DRAFT – 05.31.2022

Campus Plan Amendment: Related to the area southeast of the Franklin Circle Design Area

Proposed *Campus Plan* Amendments: Maximum Allowed Densities, Open Space Framework, and Design Area Special Conditions

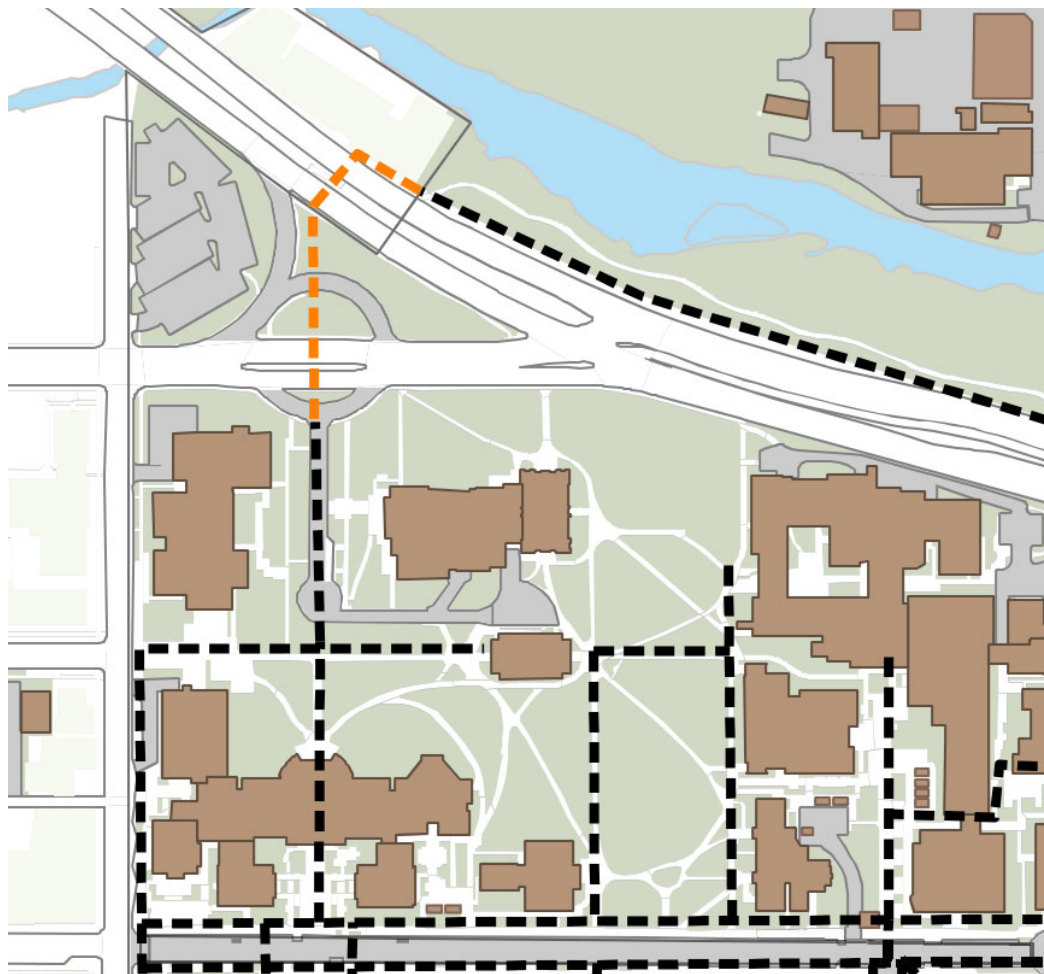
The FVP made a recommendation for extending the pedestrian pathway network in the area (see diagram below).

Map of Design Areas and the existing Franklin Circle Design Area (*Campus Plan* page 50 and page 111)

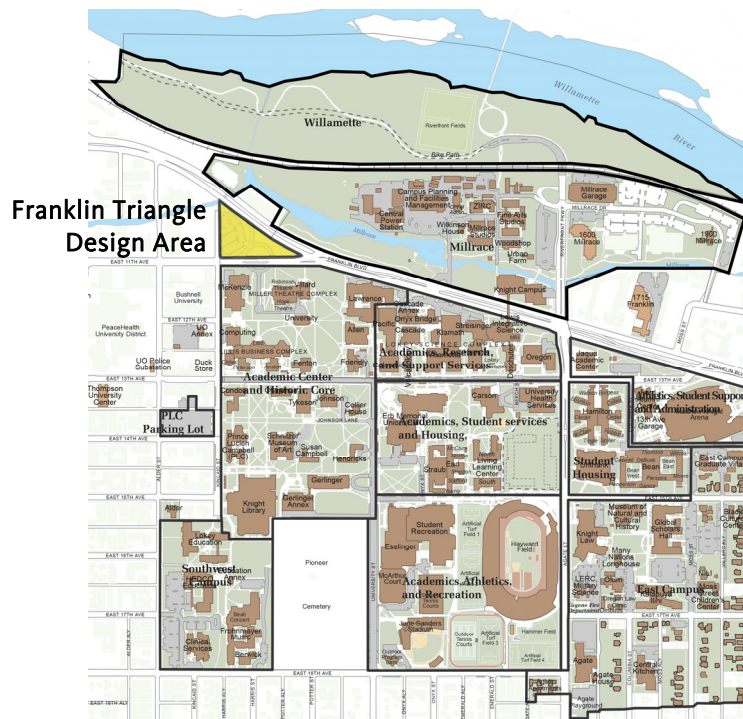
- A. Amend the *Campus Plan* Map 5: Design Areas (page 50) to incorporate the new design area of the Franklin Triangle Design Area, as shown in the map below. Remove the Franklin Circle Design Area description (page 51).

Map of Design Areas and the proposed Franklin Triangle Design Area (*Campus Plan* page 50 and page 111)
